**Site Audit Report, Former
Mobil Service Station, 25-27
Market Street Merimbula**

Prepared by:
ENVIRON Australia Pty Ltd

Date:
April 2014

Audit Number:
RS 001

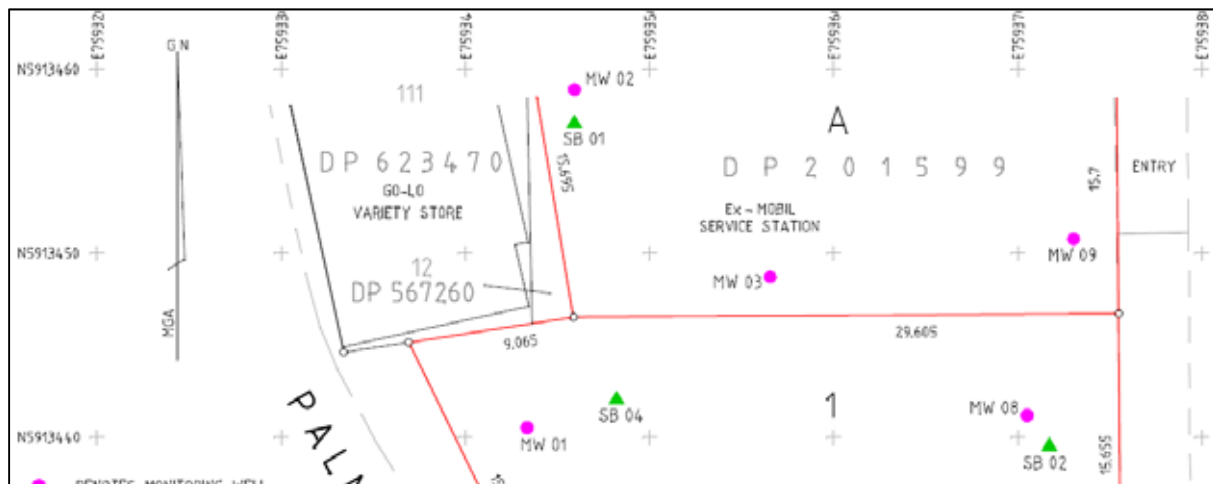
Lot 12 DP 567260 is a thin triangular lot in the northwest of the site that was not referenced in the reports reviewed or included within the site area on plans. However, based on the survey extract below and photographs of the excavation performed in the northwest of the site that show the excavation adjoins the variety store building, the Auditor is satisfied that the remediation works have encompassed this lot and therefore it is included within the site audit area.

Figure 5a
STAGE 1
SOIL SAMPLE LOCATIONS AND ANALYTICAL RESULTS

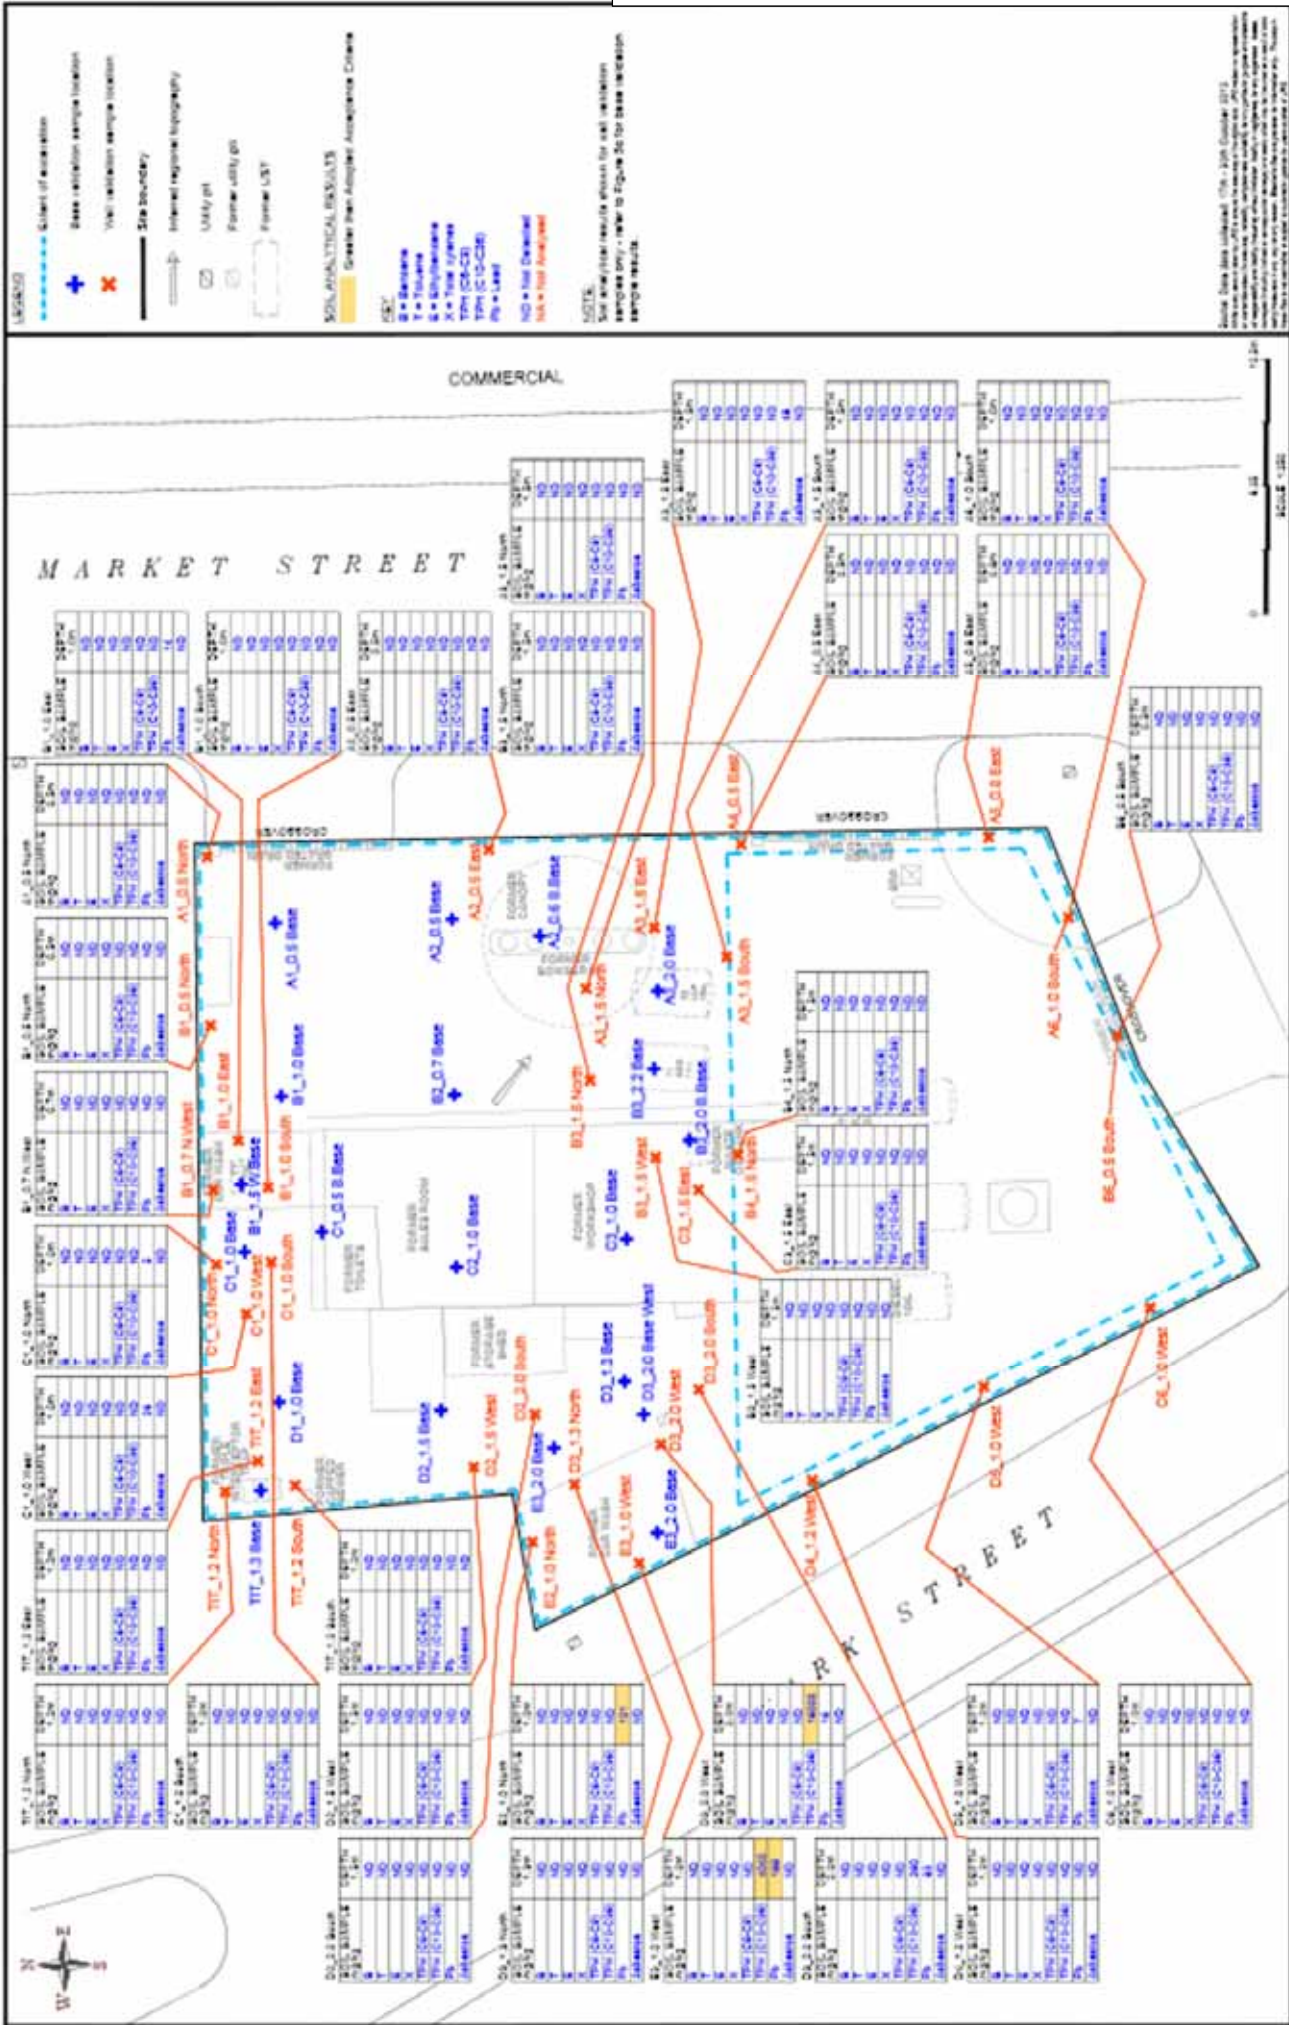
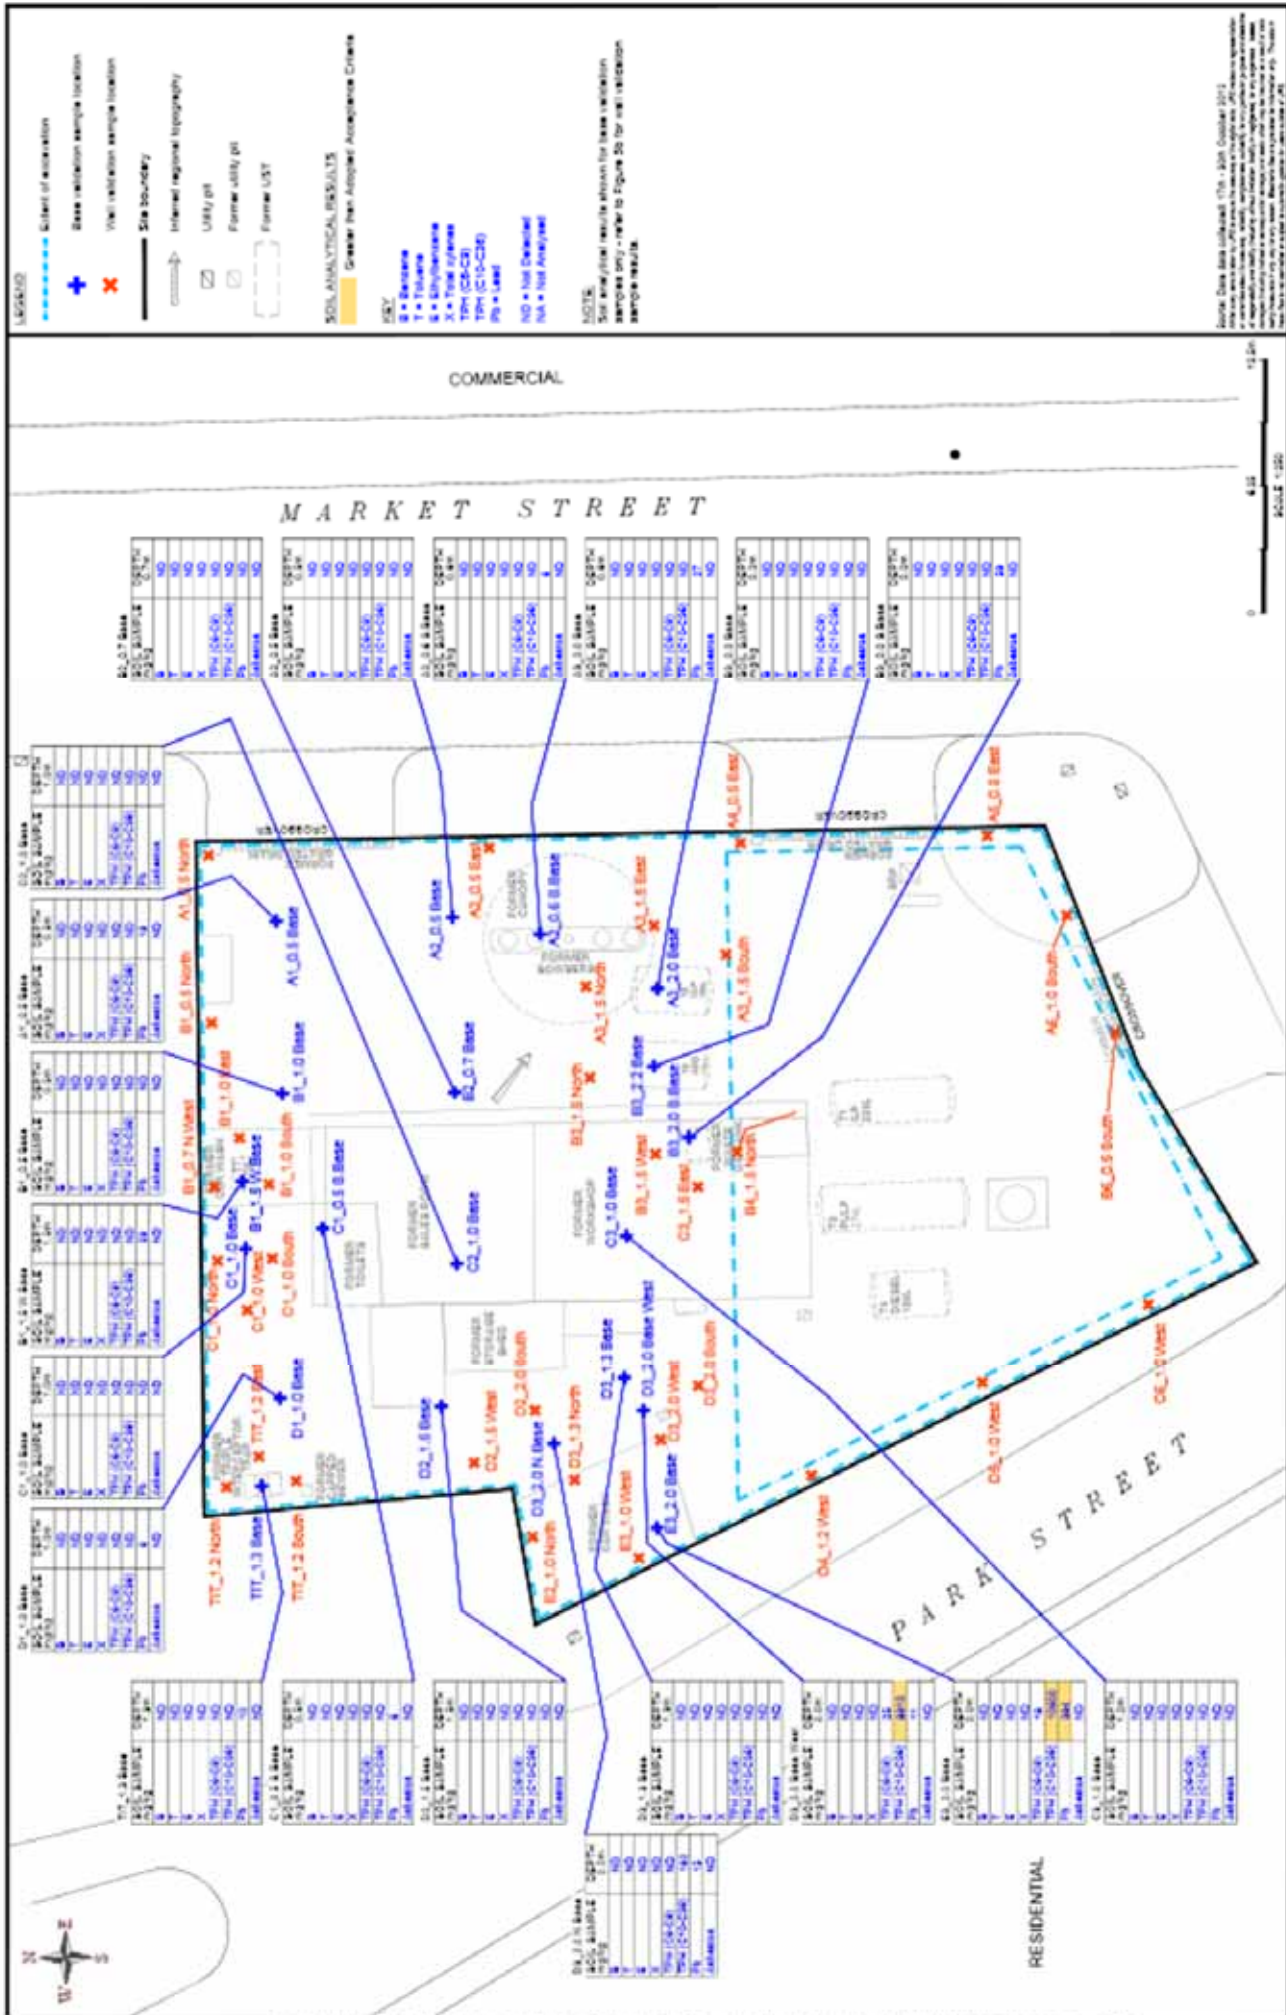
Item No	Auditor Comments	URS Response
7	Table 3a of SER - Validation sample D3_2.0 West Base is marked on the plan, however two later validation samples appear to have been collected in this area (with higher TPH concentrations). These later samples are not marked on the plan (D3_2.0 BASEWEST and D3_2.0 West_B). Were these final excavation samples?	<p>Validation samples were collected during the Stage 2 excavation works. However, additional soil samples were collected while undertaking further drilling works onsite on 13 November 2012 at these locations.</p> <p>The maximum concentration detected from these samples were to be used in the report; however, in the case of the sample in question (D3_2.0 West Base), it appears there may have been an oversight. The Risk Assessment carried out was based on groundwater results, and due to the shallow nature of the groundwater onsite, the risks based on these values are covered off in the risk assessment and does not change the conclusions of the risk assessment.</p>
